# Memorandum

To: Salt Lake City Historic Landmark Commission  
From: Aaron Barlow, Principal Planner, [aaron.barlow@slcgov.com](mailto:aaron.barlow@slcgov.com) or 801-535-6182  
Date: June 1, 2023  
Re: PLNHLC2022-00675 – Trolley North Student Housing Development

This memorandum provides updated information on the proposed Trolley North Student Housing Development New Construction Petition PLNHLC2023-00675. The referenced application was discussed at the Historic Landmark Commission Meeting on January 5, 2023. At that meeting, the commission tabled the request citing shortcomings in the submitted materials and failure to comply with a number of standards. Their feedback was articulated in a letter sent to the applicant (dated January 17, 2023, included in [Attachment I](#)) and was based upon the standards of review for New Construction in a Historic District ([21A.34.020.H](#)) and the Design Guidelines for Historic Apartment and Multifamily Buildings found in [Chapter 12](#): New Construction.

# Comparison of Previous and Revised Submittals

**Site Plan**  
Original Submittal

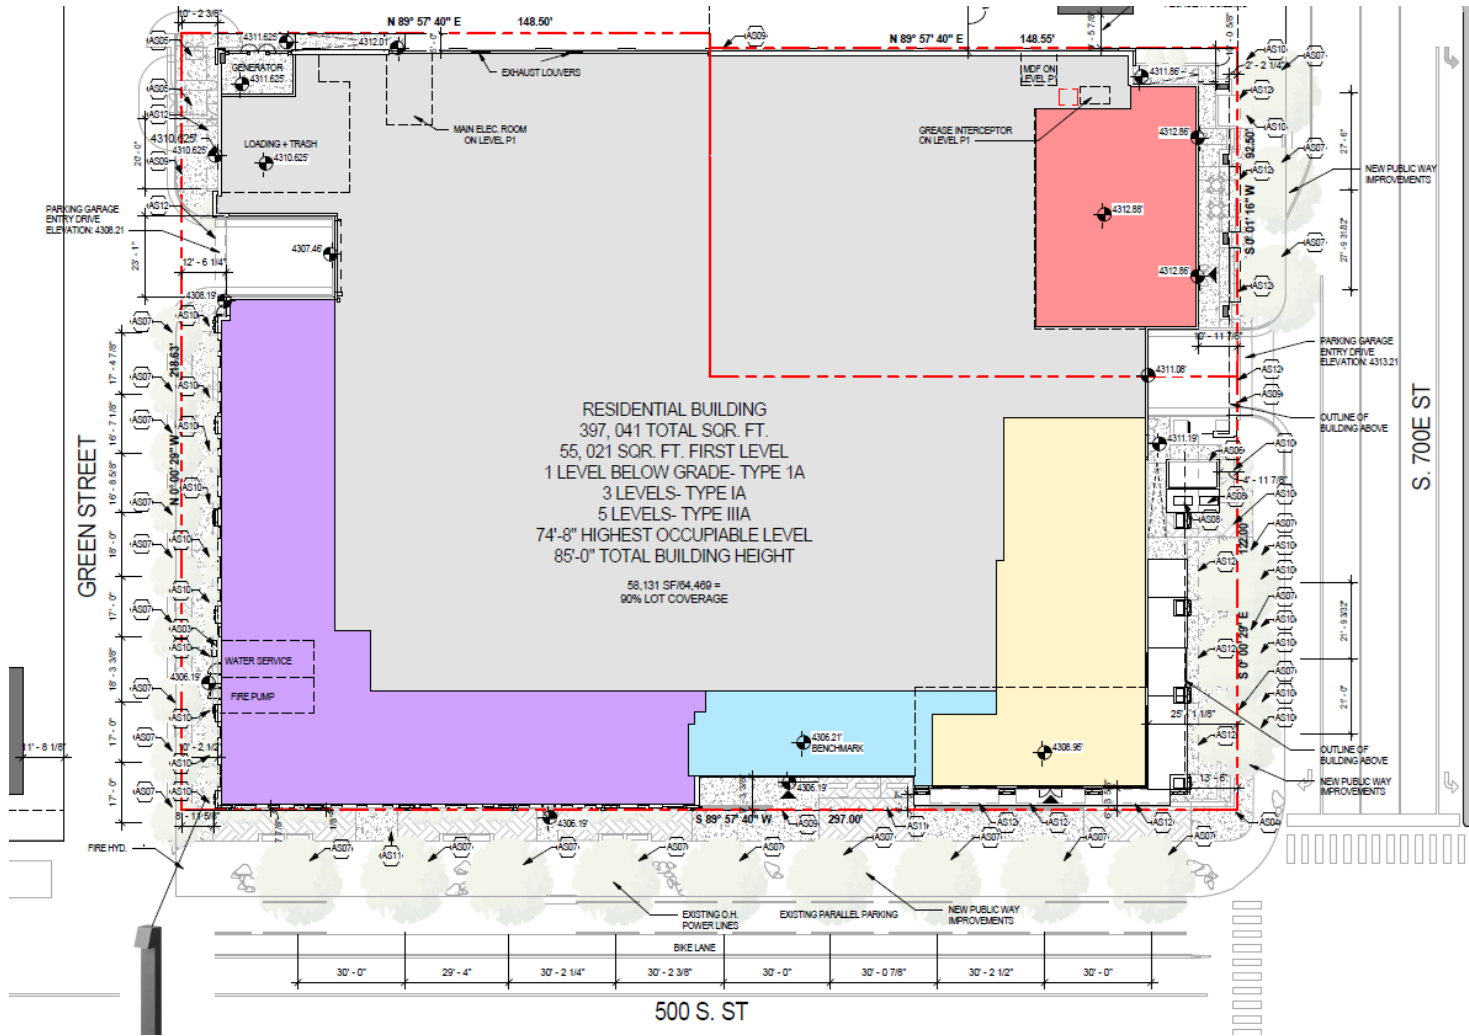
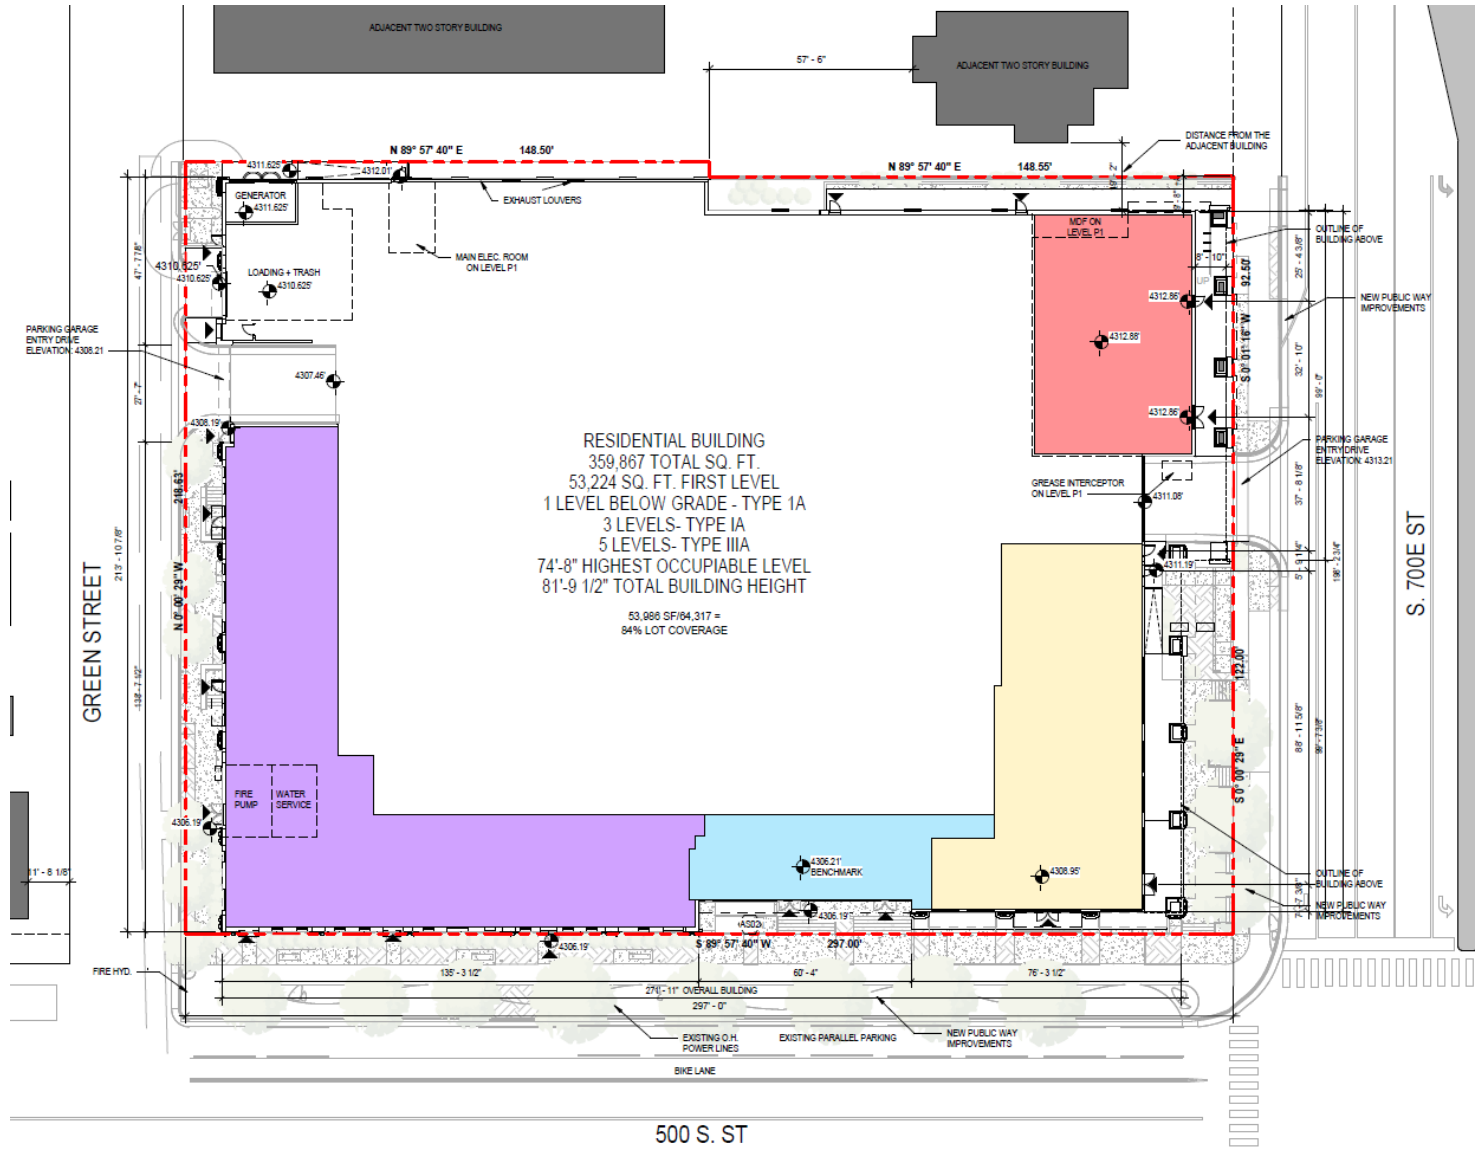
The revised plans show that the parking ventilation utility box that was proposed in front of the 700 East façade has been removed and alternative accommodations have been moved to the west side of the north façade.

### Shade Study

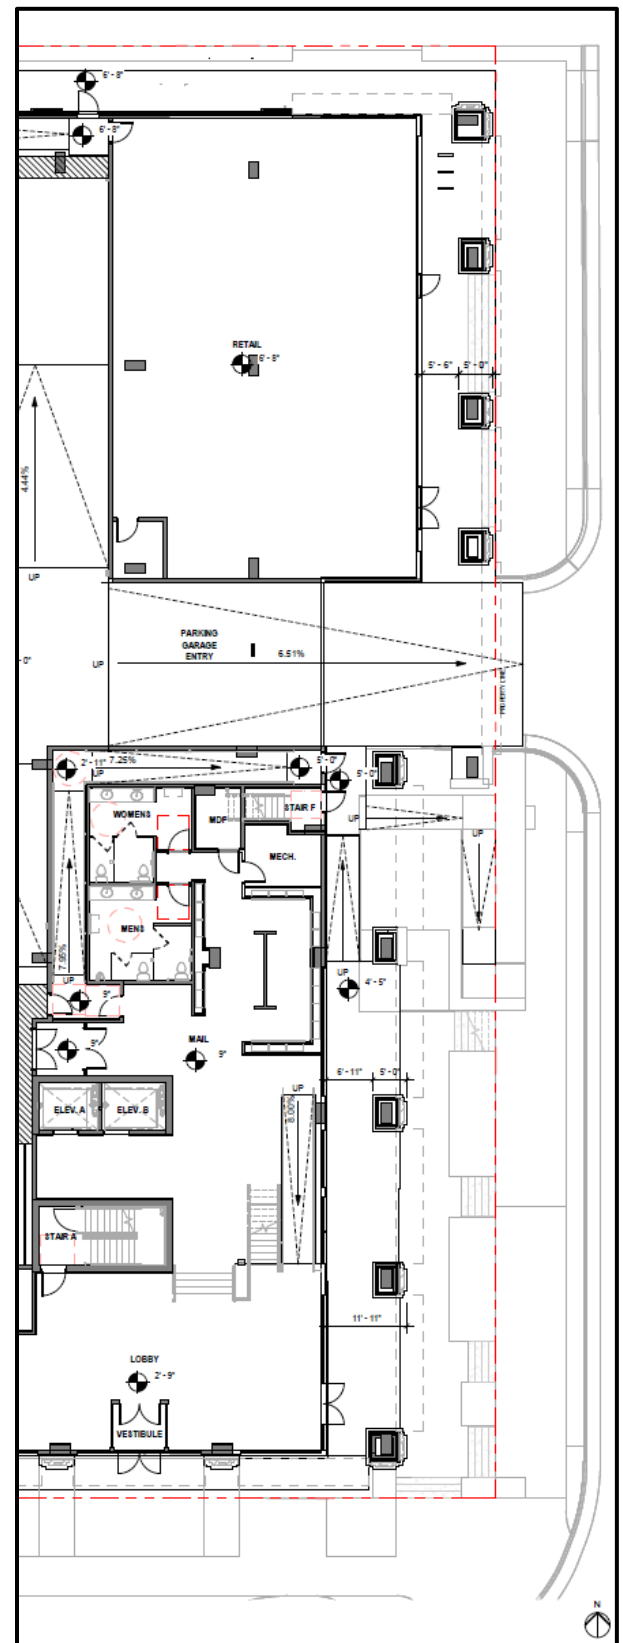
The new plan set includes a shade study showing the anticipated light impacts of the proposed development during different times of the day. The study illustrates that the building would impact the Mulloy (Hancock) Mansion's access to sunlight but would not cover the property in year-round shade.

*Elevation Massing Studies – Each color represents a different vertical plane.*

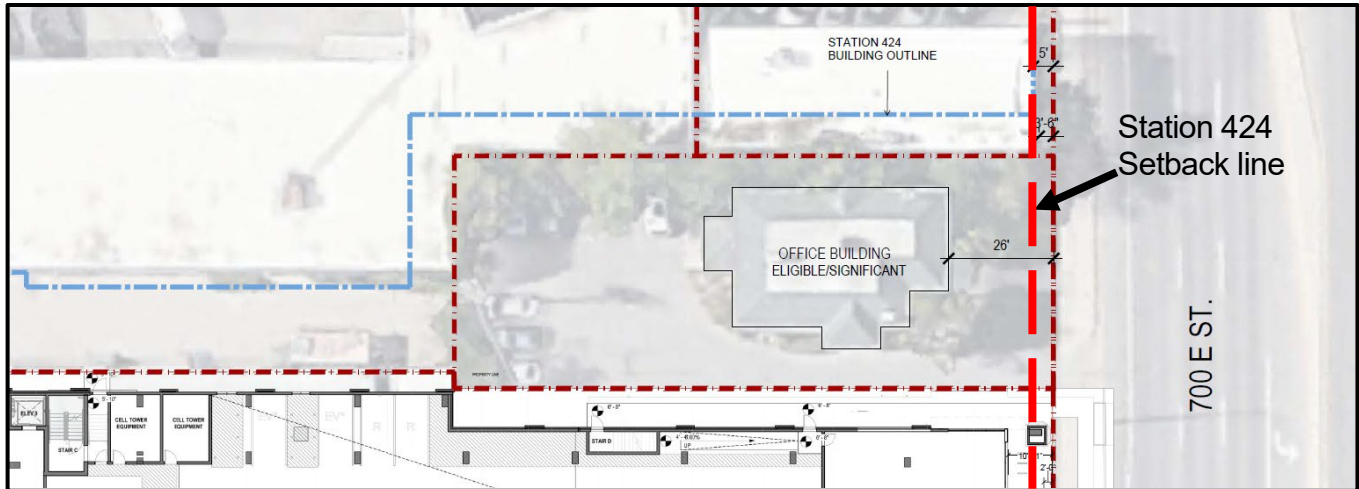
- The façade facing Green Street now features more openings at the base and large windows on the south end.
- The 500 South façade features a mural above the main entrance to better separate the two larger masses on either side. The large windows mentioned above wrap around and cover the upper levels of the west section of the façade, shrinking the perceived width.
- The 700 East façade differs substantially from the previous proposal. Like the southwest corner of the building, the plans show a new wall of glass covering the upper floors of the building's northeast corner. The revisions also include an additional step back at the northeast corner, creating a patio area above the retail space. The revised plans also have increased the north building setback from the adjacent property.

# LANDSCAPE PLAN

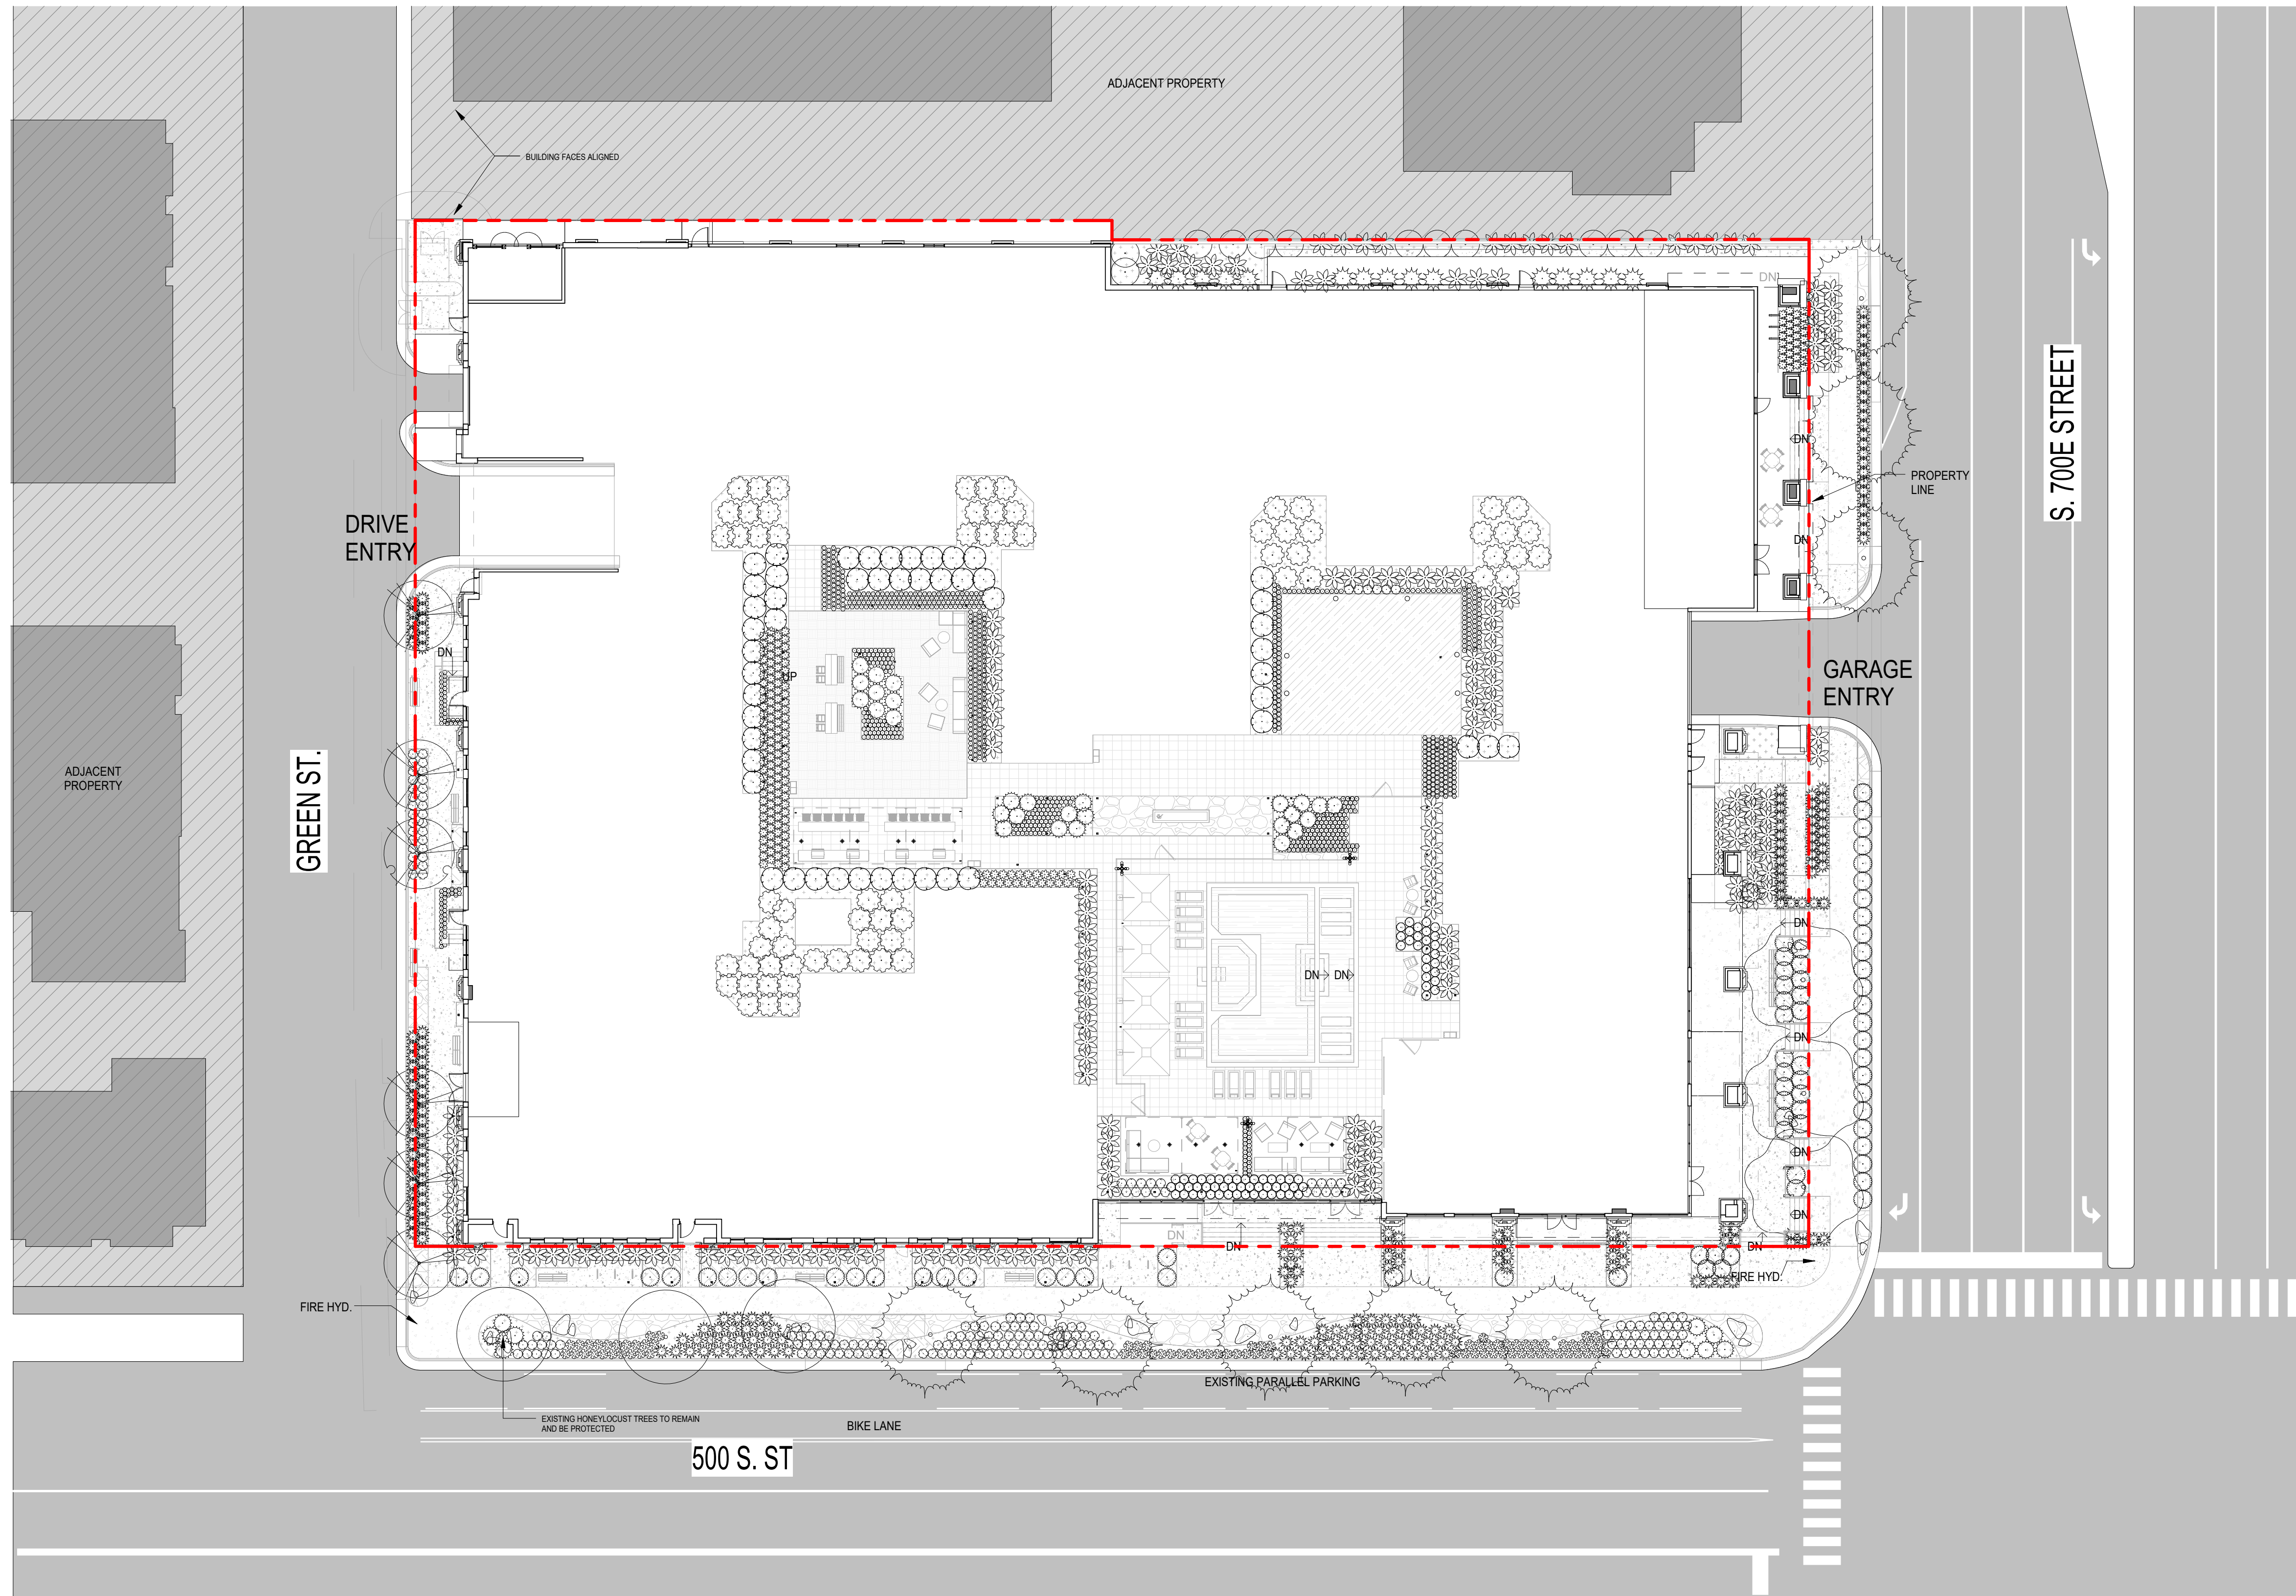
The plan set includes an updated landscaping plan and the proposed location and types of plant materials meet the requirements of the underlying zoning district. Trees are proposed along each street-facing façade. The walkway along Green Street would have ample shade to improve the experience of pedestrians.
